D3391-041 FLOAT SKIDTUBE ASSEMBLY PARTS LIST

DESIGN	PH	DART AEROSPACE USA, INC	
DRAWN	AJS	PORT HADLOCK, WA	
CHECKED	<i>[Signature]</i>	DRAWING NO.	REV. H
MFG. APPR.	<i>[Signature]</i>	D3391	SHEET 3 OF 8
APPROVED	<i>[Signature]</i>	TITLE	SCALE
DE APPR.	<i>[Signature]</i>	412 FLOAT SKIDTUBE	NTS
DATE	08.08.20	COPYRIGHT © 2005 BY DART AEROSPACE USA, INC. THIS DOCUMENT IS PRIVATE AND CONFIDENTIAL AND IS SUPPLIED ON THE EXPRESS CONDITION THAT IT IS NOT TO BE USED FOR ANY PURPOSE OR COPIED OR COMMUNICATED TO ANY OTHER PERSON WITHOUT WRITTEN PERMISSION FROM DART AEROSPACE USA, INC.

DRAWING NO. D3391	TITLE 412 FLOAT SKIDTUBE	REV. H	DART AEROSPACE USA, INC ENGINEERING ORDER		D.E.O. NO. D3391-H-1	SHEET NO. SHEET 1 OF 1	SCALE NTS
DRAWN <i>CP</i>	CHECKED <i>h</i>	MFG. APPR. <i>MS</i>	APPROVED <i>MP</i>		DE APPR. <i>h</i>		
DATE 09.09.23	DATE 09.09.24	DATE 09/09/25	DATE 09/09/30		DATE 09/09/30

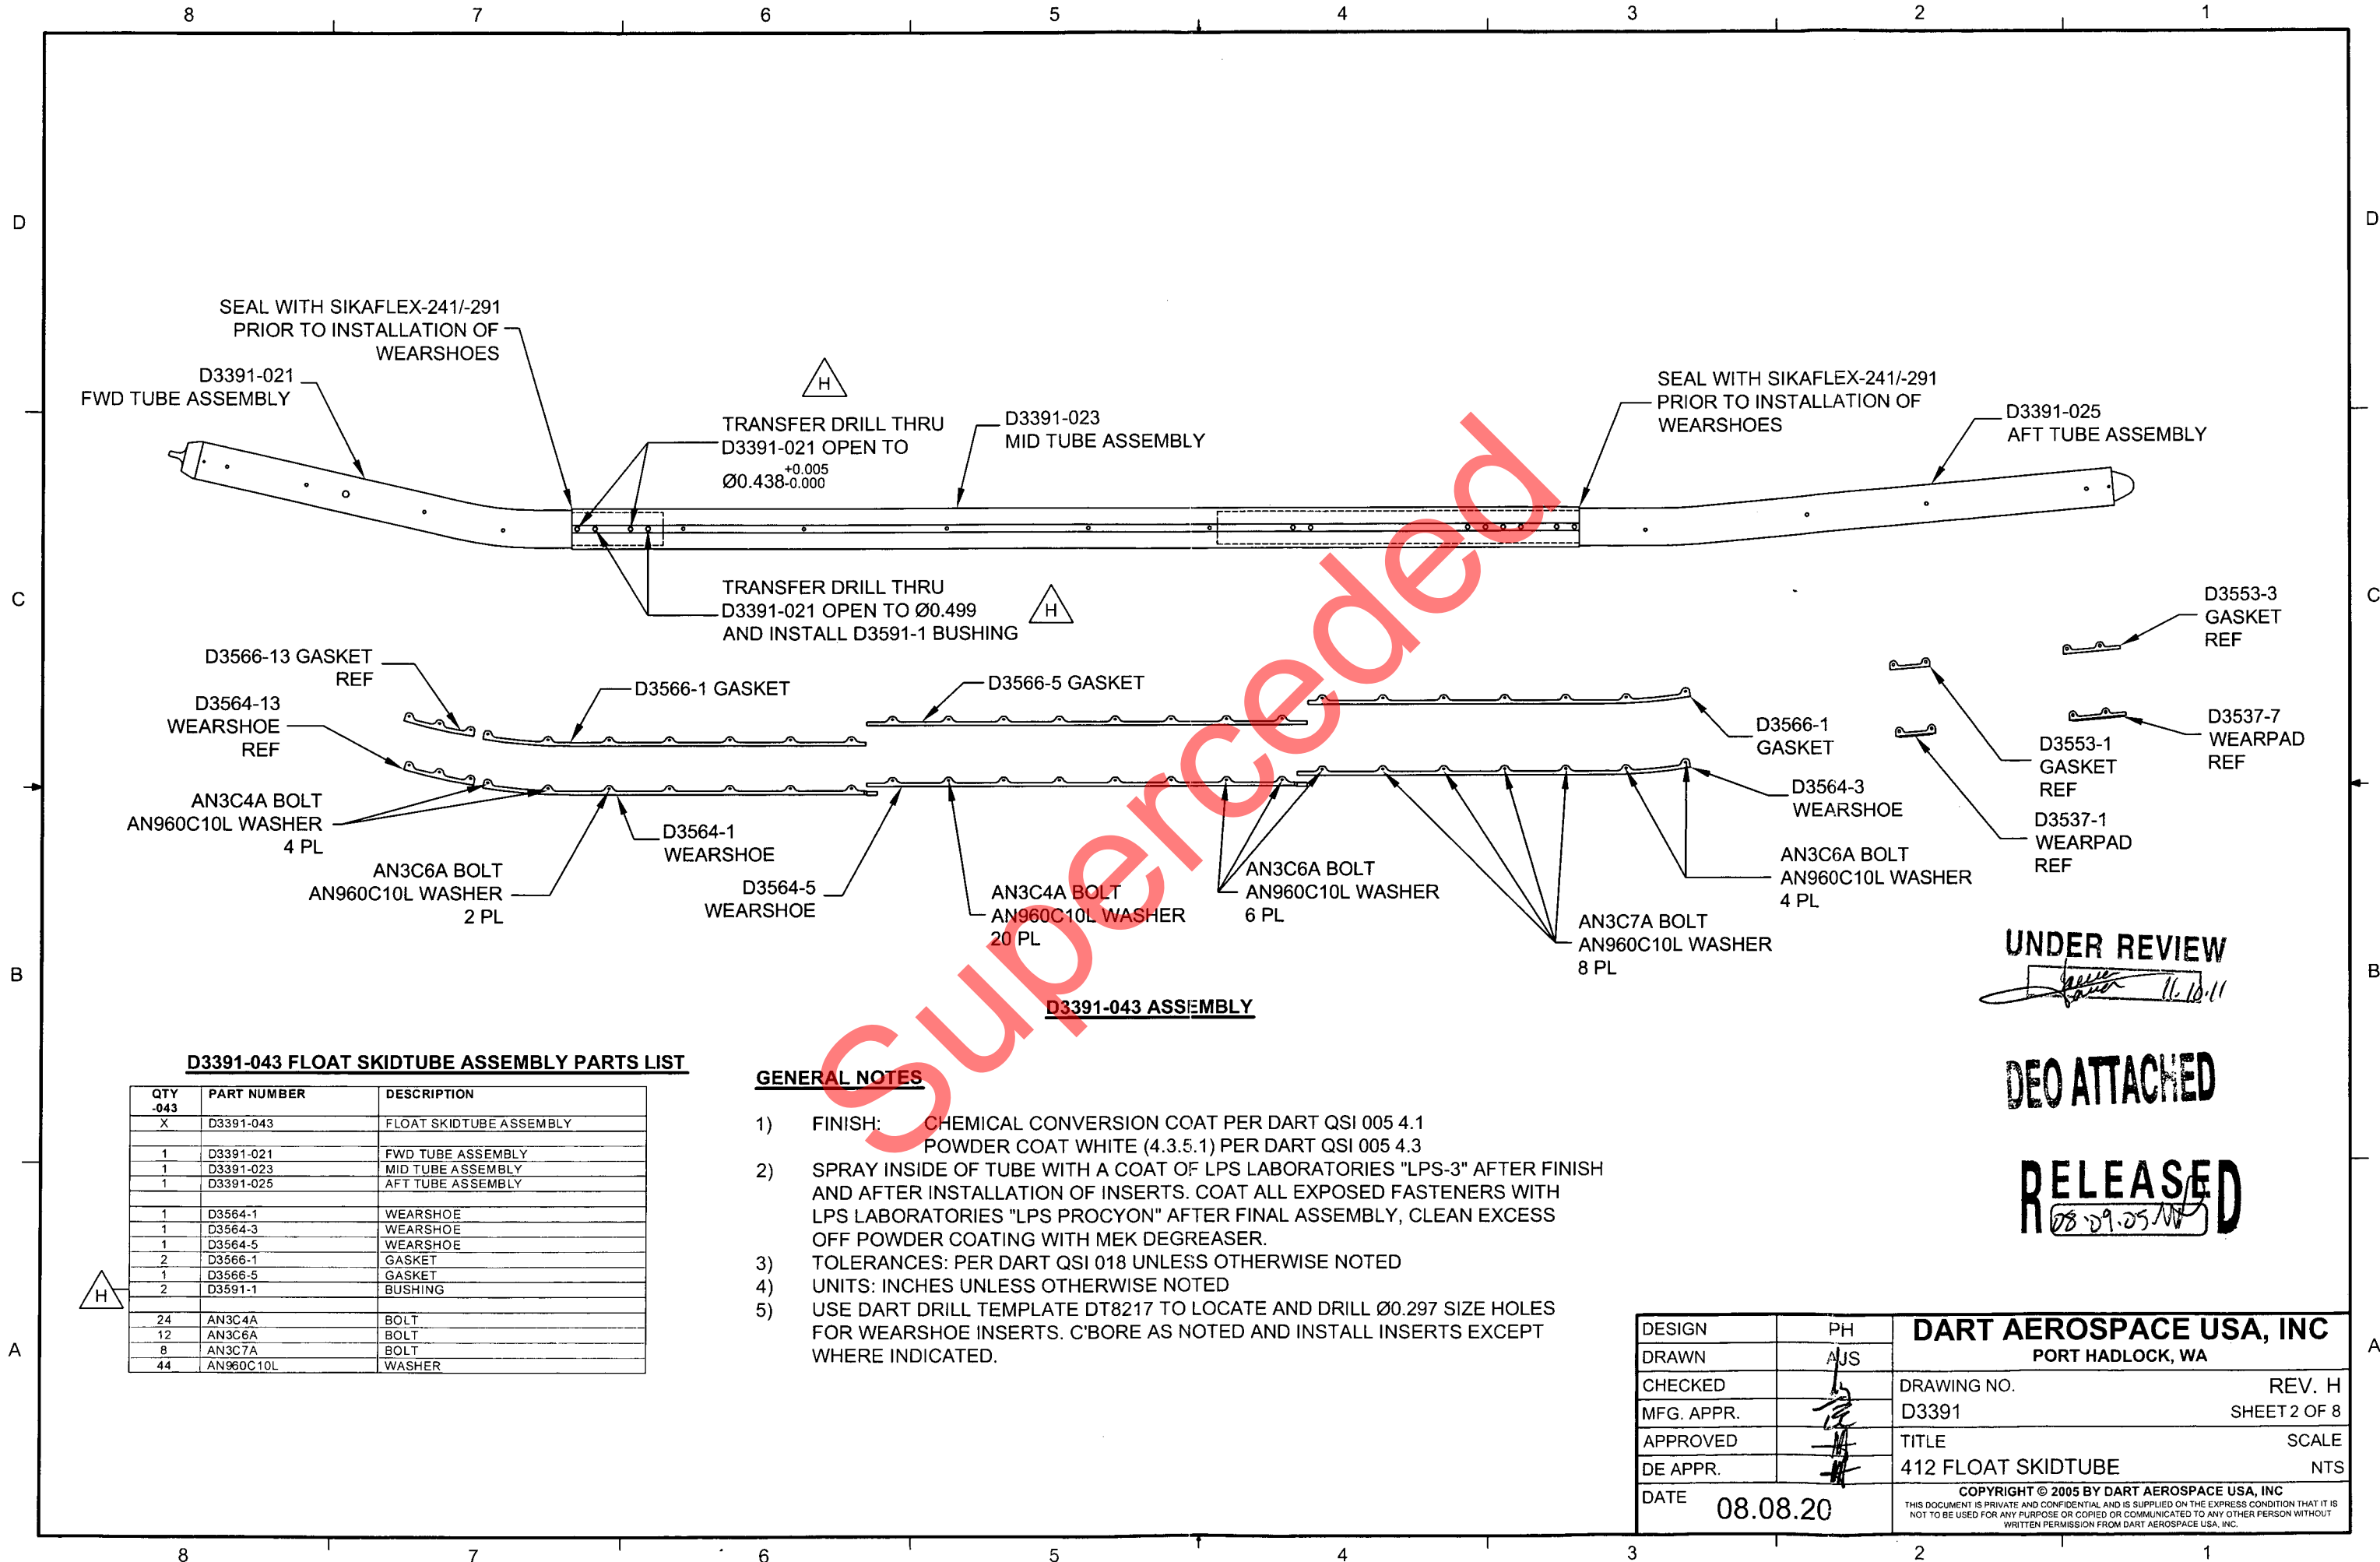
LPS-3 IS NO LONGER USED DURING ASSEMBLY OF D3391-041/-043 SKIDTUBES.

AMEND NOTE 2 OF D3391-041/-043 SKIDTUBE ASSEMBLIES (ZN A6-1, A6-2) AS FOLLOWS:

- 2) ~~SPRAY INSIDE OF TUBE WITH A COAT OF LPS LABORATORIES "LPS-3" AFTER FINISH~~
~~AND AFTER INSTALLATION OF INSERTS. COAT ALL EXPOSED FASTENERS WITH~~
LPS LABORATORIES "LPS PROCYON" AFTER FINAL ASSEMBLY, CLEAN EXCESS
OFF POWDER COATING WITH MEK DEGREASER.
